Engineers Comments Regarding Surface Water Drainage

Application Reference:	F/14/24/RES	Reviewer Reference:	ADC/SB
Planning Officer:	Jessica Riches	Date of Review:	28/02/2025
Site Name:	Land at Ford Airfield Ford		
Application Description:	Approval of reserved matters (layout, scale, appearance and landscaping) following outline consent F/4/20/OUT for the infrastructure reserved matters including the provision of a primary spine road and associated secondary road junctions, pavement, footpaths, cycle infrastructure and bus stops; site wide drainage infrastructure including foul pumping stations, foul sewer infrastructure, SUDS basins, SUDS swales, surface water infrastructure; acoustic fencing; public open space including landscape details, play areas, footpaths & associated works. This application affects a Public Right of Way, may affect the setting of a Listed Building and falls within CIL Zone 1 (Ford strategic site - zero rated).		
Assessment Number:	1 of 1

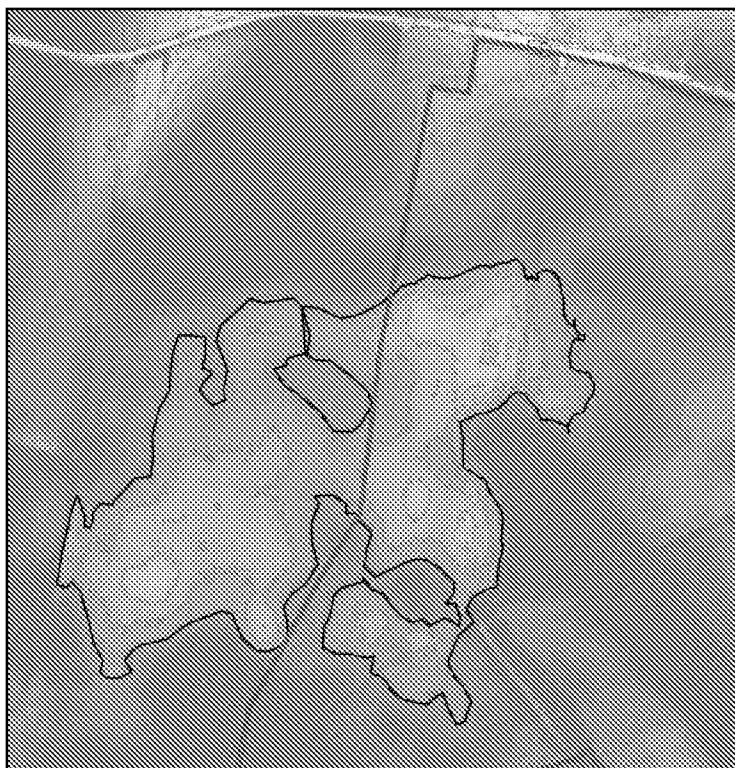
We have produced the attached LIDAR plan which illustrates the topography of the site, high ground is shown in blue, and low in red. Contours are shown for every 0.2m change in elevation. The planning officer should be aware that this is not information submitted by the applicant but serves as an evidence base to support our rationale.

The LIDAR plan shows that there are depressions in the land where you would expect surface water to accumulate and infiltrate as there is no watercourse in these locations. Where water could not infiltrate, it would overflow to the northwest, presumably to the watercourse at Long Barn. For this to occur, there would be a significant volume of water flooding the land at depths of up to 0.8m. This is shown on the snip from the LIDAR plan below, the snip highlights the overflow contour in black:
